## Technical Note 1

### Land to the east of St Nicholas - Planning Ref: 2016/00619/FUL

2. This Technical Note has been produced in response to comments received from the Vale of Glamorgan's (VoG) Highway Officer (dated 20<sup>th</sup> July 2016), in relation to the proposed site access options. These comments are contained in **Appendix A**.

## Vale of Glamorgan Highway Authority Observation Sheet

**Potential Ghost Island Right Turn Arrangement**

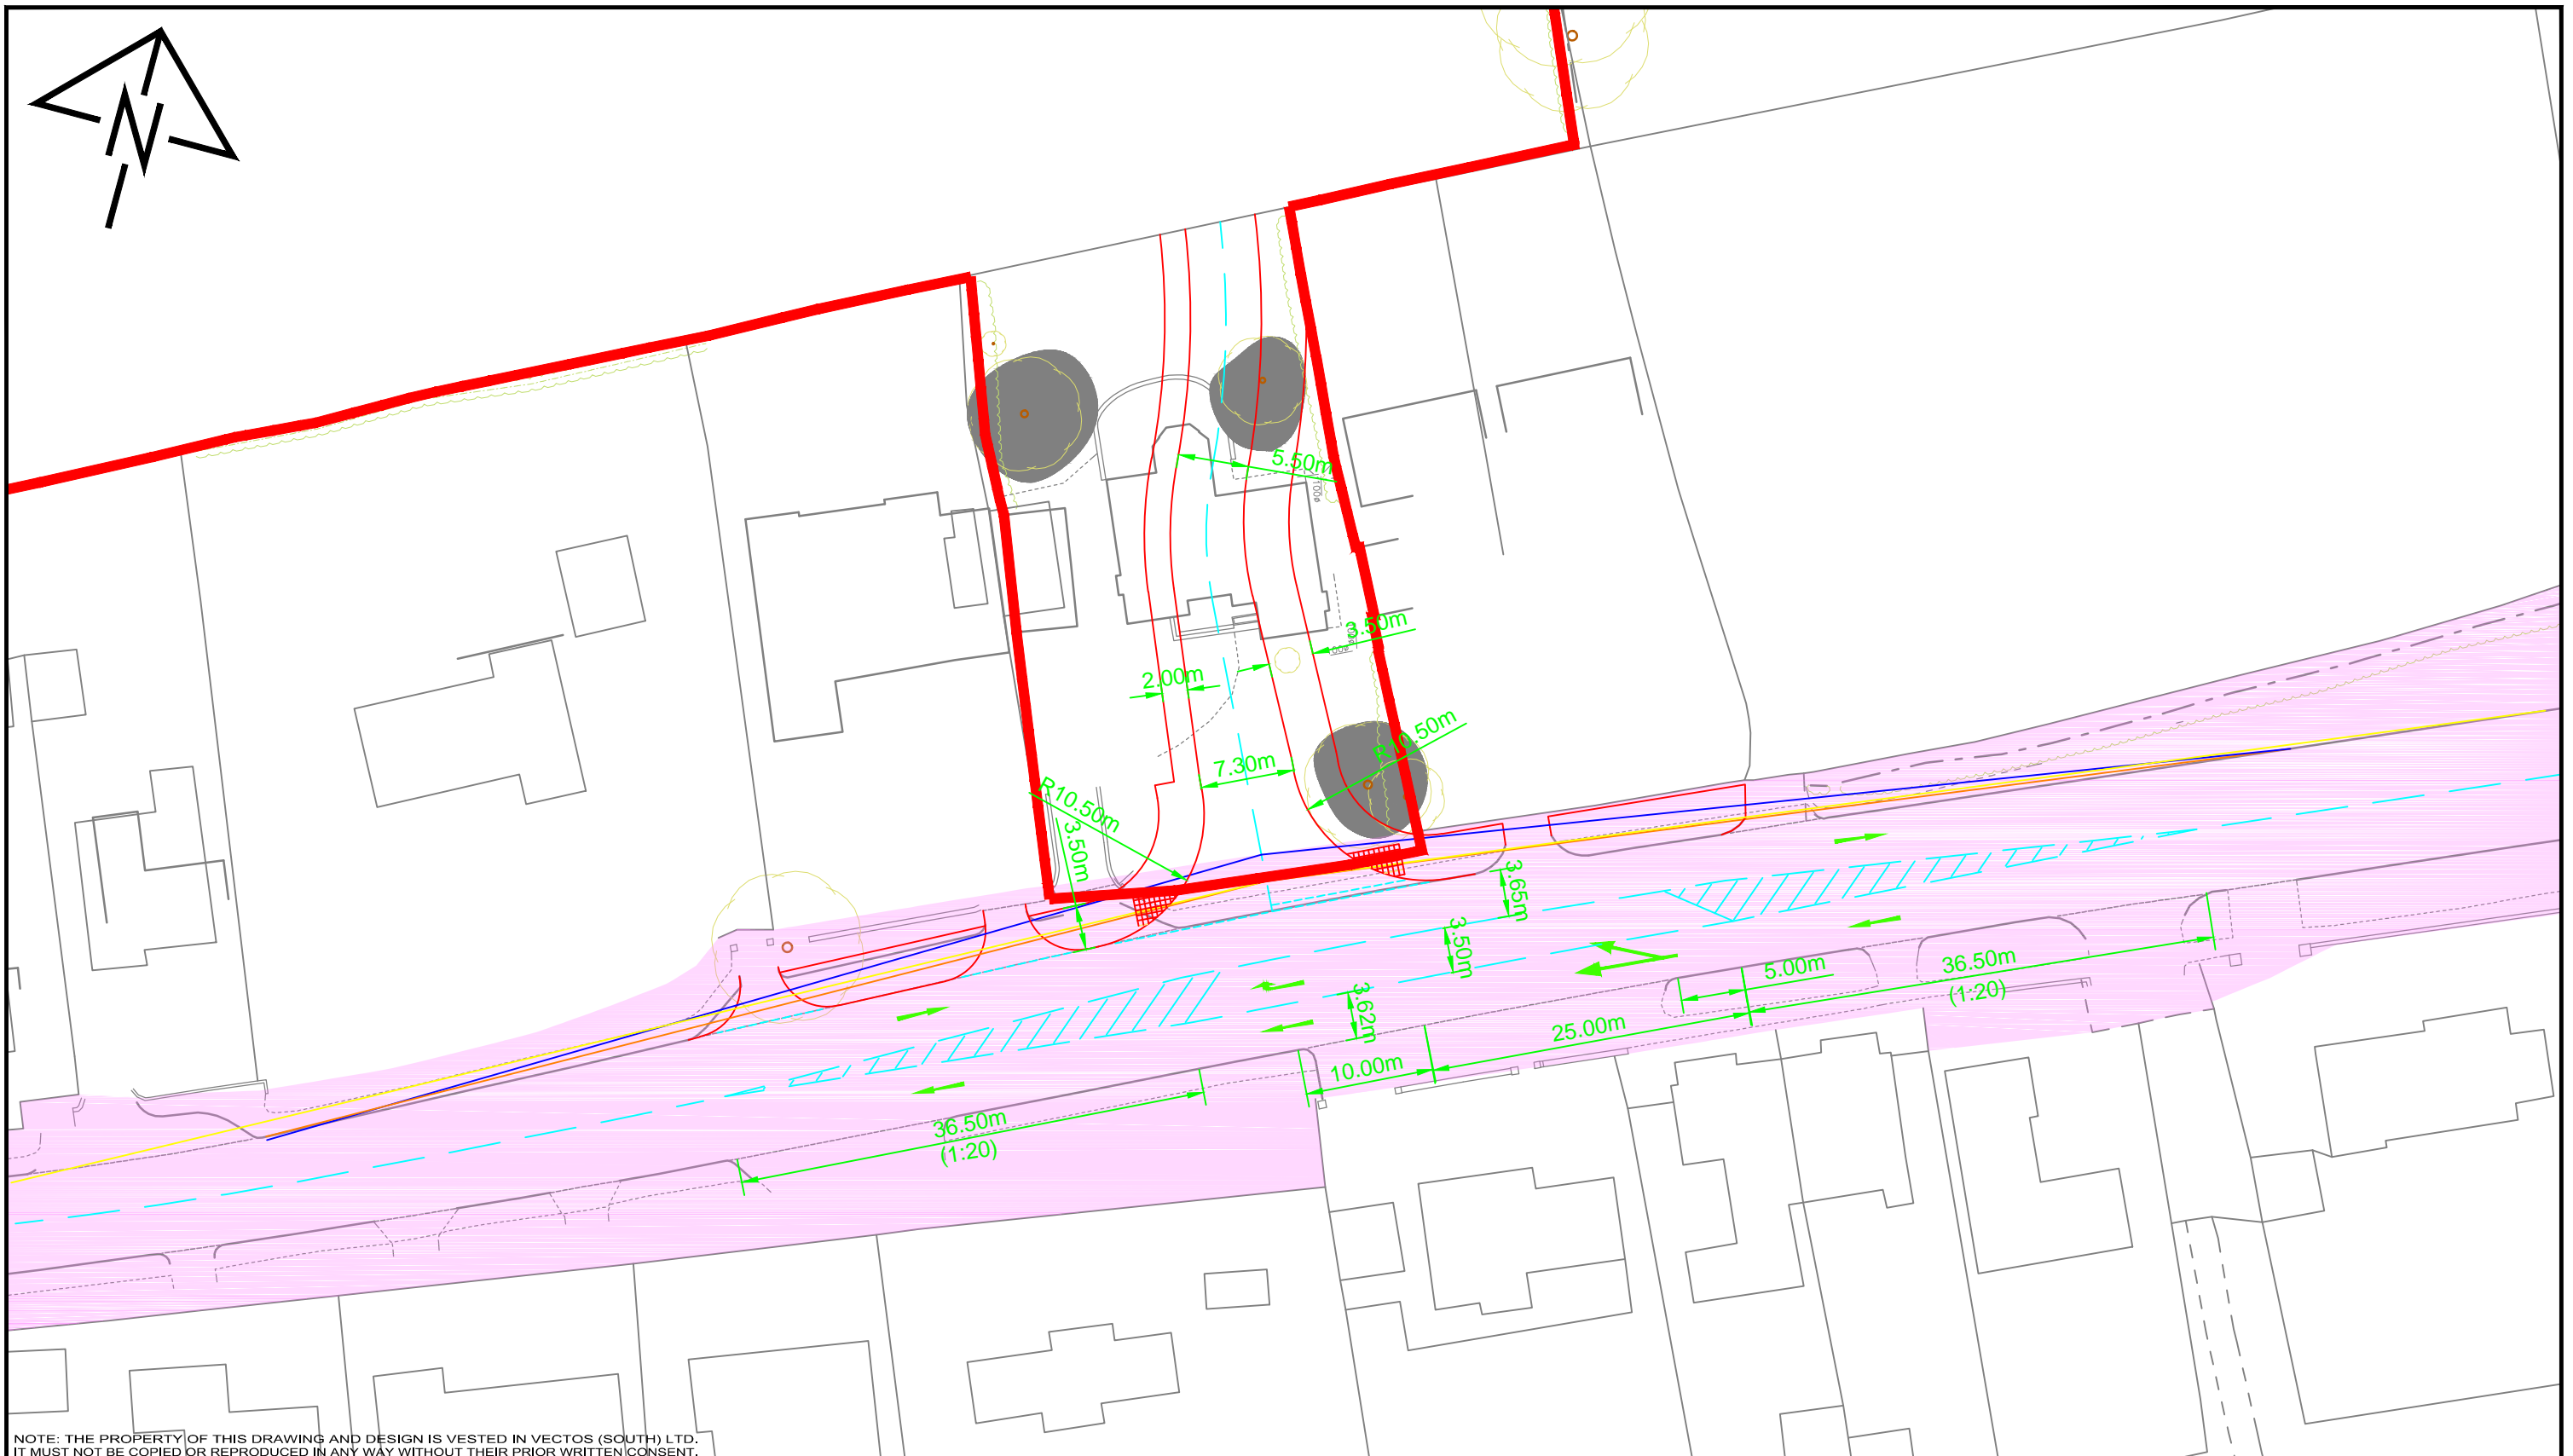
10. Notwithstanding the above, the Stopping Sight Distance (SSD) requirements for vehicles travelling at 39.4mph is 98.5m (desirable) or 77.4m (minimum). The Highway Officer has requested visibility splays of 100m desirable or 80m minimum, which are higher.

In terms of visibility splays, the developer has incorporated a Plan within the Transport Assessment, reference W141341 / A03 Rev D which identifies a 2.4m x 40m & 4.5m x 70m visibility splays in both directions. However, the Highway Authority would advise the Local Planning Authority that based on the both of the 85<sup>th</sup> Percentile Speeds submitted as part of the applicants Transport Assessment (TA) , the proposed “ y “ distances of 40m & 70m

respectively would **not** achieve the Desirable Minimum Safe Stopping Distance (SSD) of 100m **or** even the Absolute Minimum SSD of 80m based on parameters laid out within Manual for Streets 2 in conjunction with an the required “ x ” distance into the junction of 4.5m. While it would appear from reviewing the aforementioned plan it would appear that in which the highway limits are identified coloured “ pink “, all of the above visibility parameters can be achieved within highway limits and land within control / ownership of the developer, the Highway Authority will require a revised Plan to reflect the required visibility parameters for further consultation prior to determination by the Local Planning Authority.

1. The junction radii being increased to 10.5 metre ( minimum)
2. The access width being 5.5m
3. Visibility Splays 100m x 4.5m in Both Directions based on the Desirable Minimum Safe Stopping Distance and reduction to the absolute Minimum o SSD of 80m will need justification.
4. Submission of comprehensive swept path analysis of the junction area allowing for the movements of 11m ridged vehicles entering / exiting the site while there is a vehicle sighted at the minor arm junction.

11. There is no reason why the minimum SSD should not be used in this location as the review of accident statistics contained in the Vectos TS demonstrate that there is an excellent accident record on this section of the A48. The plans contained in **Appendix B** illustrate that the minimum visibility requirements at 4.5m back from the give-way line (X distance) can be achieved in both directions using the advised methodology in MfS2 (Para 10.5.3).

12. However, MfS2 recommends that the distance from the give-way lines at which visibility splays are measured, should be only 2.4m, not 4.5m. At an X distance of 2.4m, the plans contained in **Appendix B** illustrate that the desirable visibility requirements can be achieved in both directions using the advised methodology in MfS2 (Para 10.5.3).

consider that the distance of 2.4m measured from the give-way line is the most appropriate point from which to measure the visibility splays and at this distance, the junction achieves the desirable SSD for traffic travelling at 40mph.

**Swept Path Analysis using a 9.86m Large 3 Axle Refuse Vehicle**

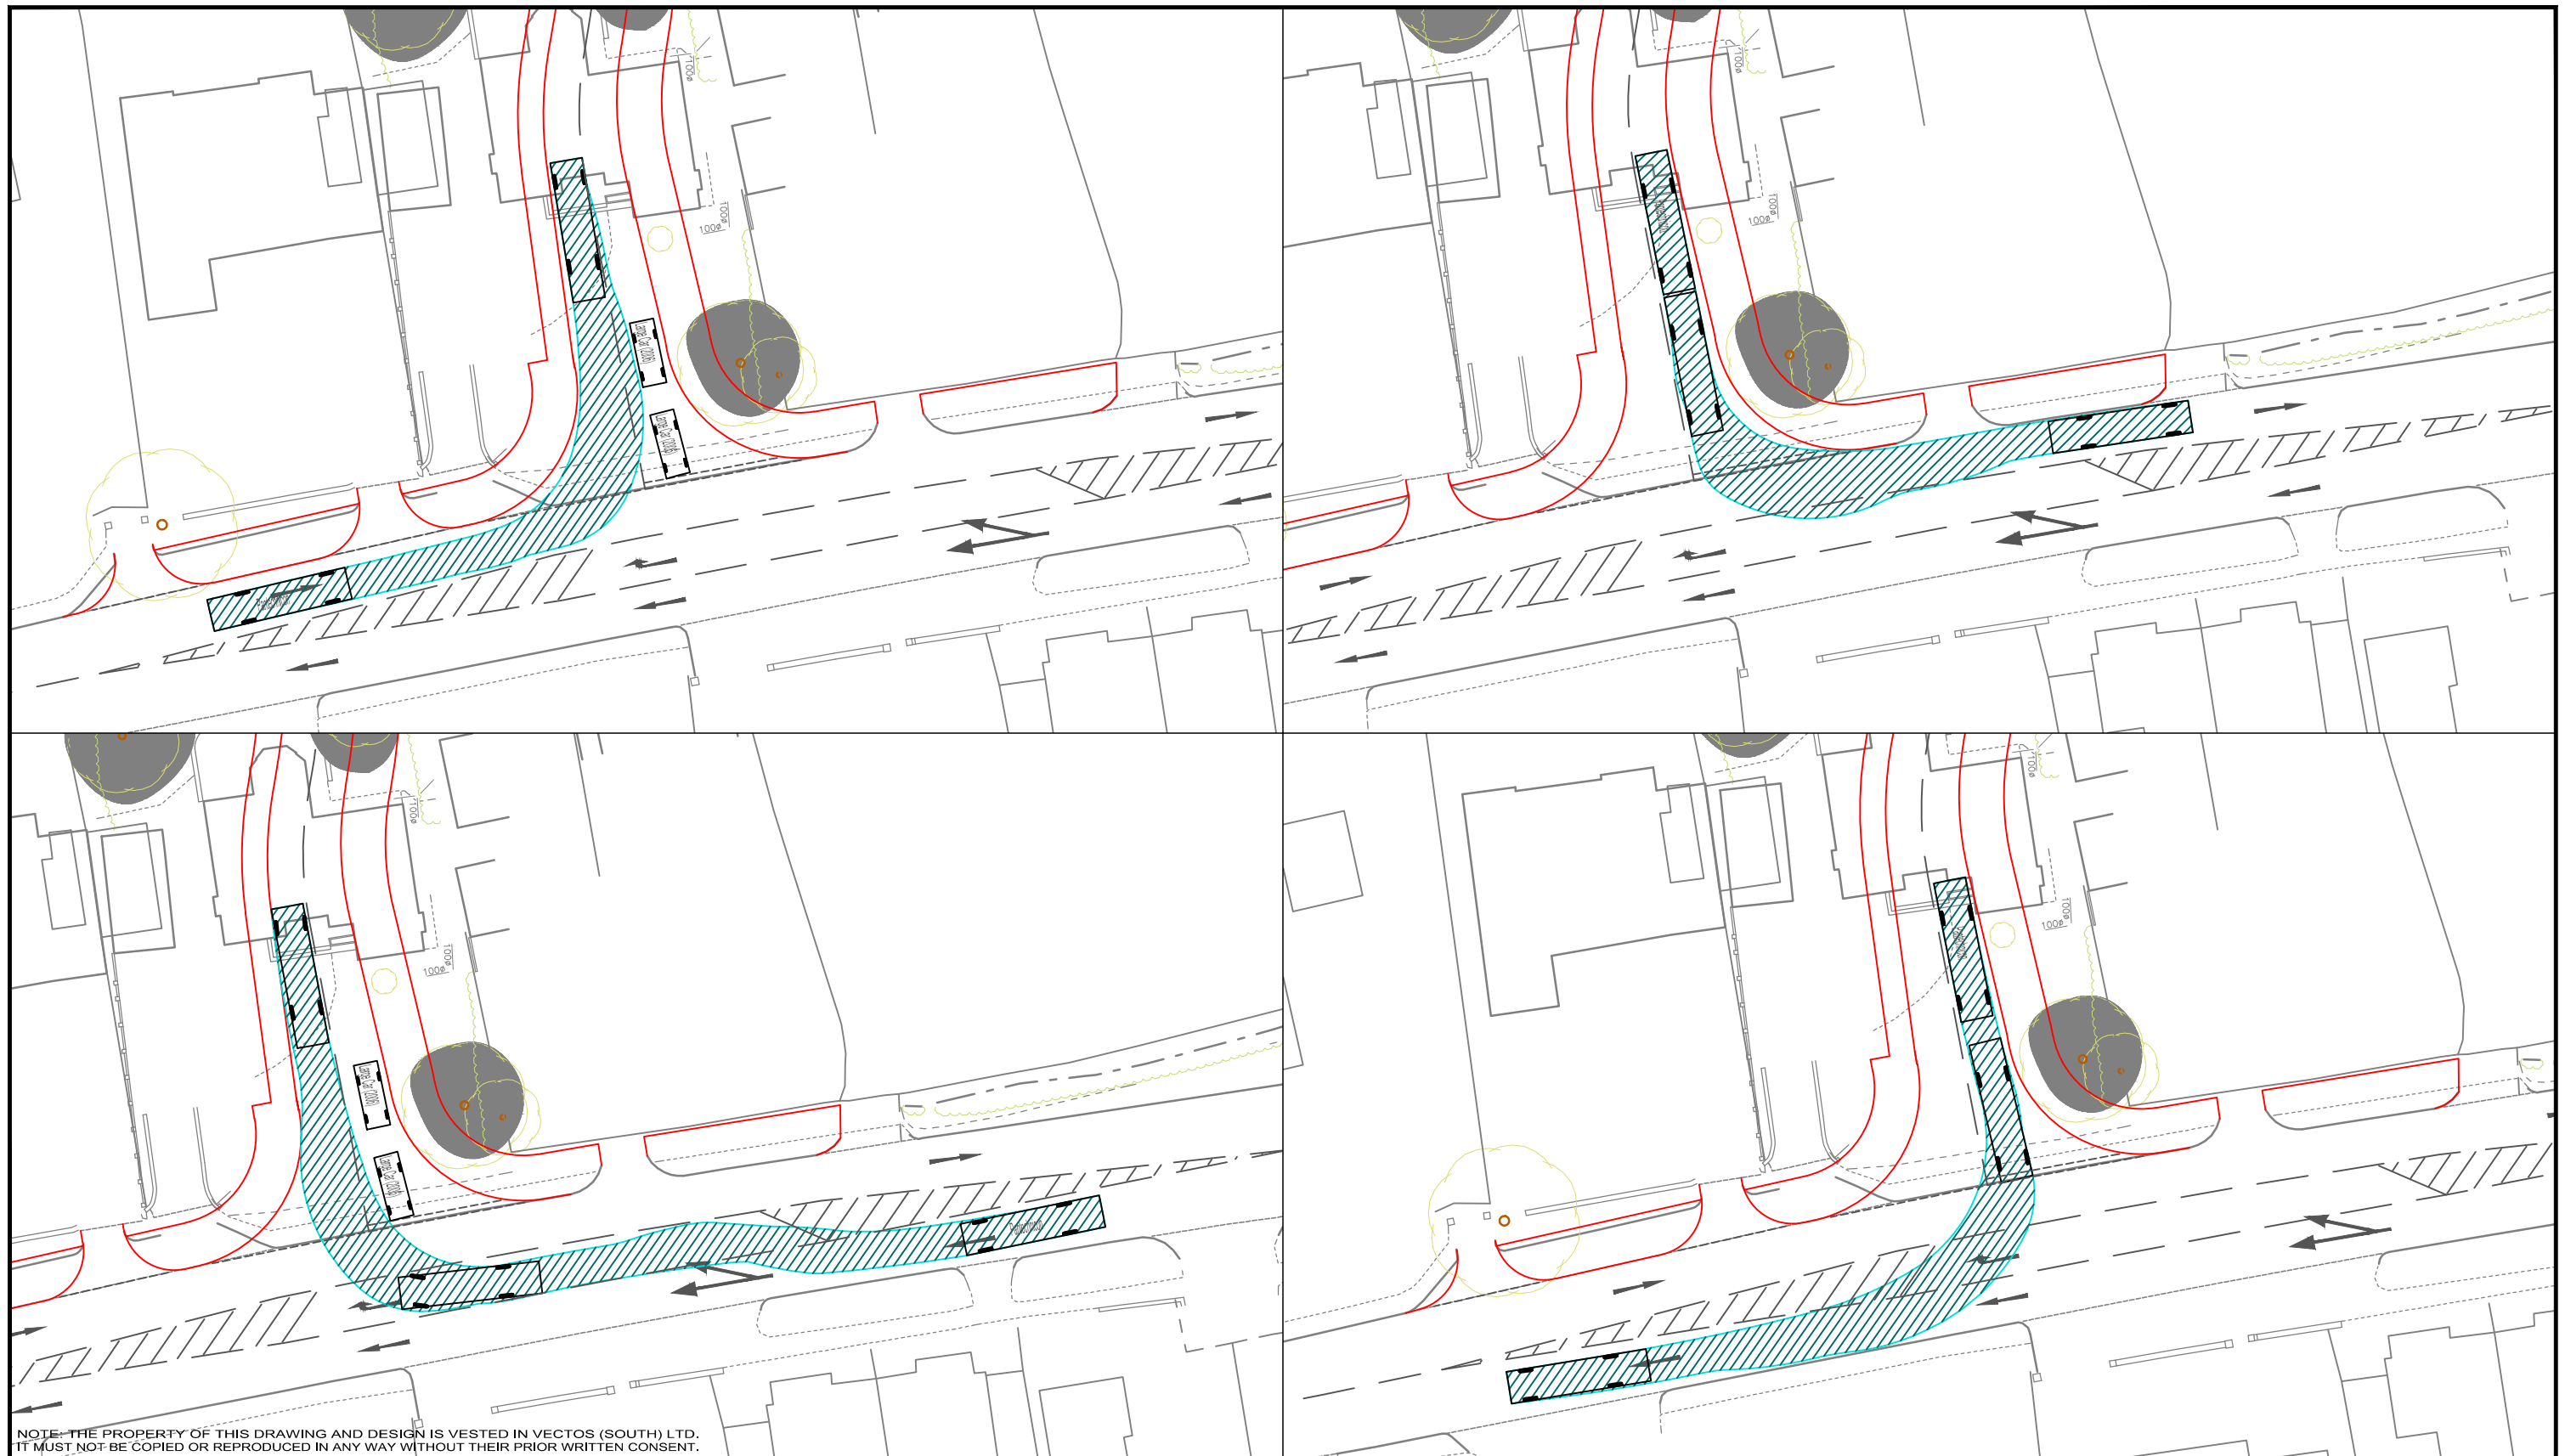
In terms of the access arrangements configuration, the Highway Authority would advise that the proposed junction radii onto the A48 for the development access of 6 metres is **not** deemed suitable at this location where there is occasional use by large goods vehicles such as refuse vehicles and removal/ delivery vehicles.

5. The revised junction arrangements for Option 1 are contained within **Appendix B**.
6. The Highway Officer requested that the corner radii be increased to 10.5m to accommodate larger refuse vehicles. This has been accommodated within the revised junction design.
7. The width of the access road has been increased to 7.3m to accommodate the swept path of a large refuse vehicle. The access road narrows to 5.5m as it enters the site.
8. Swept path Plans are contained in **Appendix B**. These plans demonstrate that:
  - (Plan H01) - A large refuse vehicle (9.86m in length) can easily access and egress the site access junction;
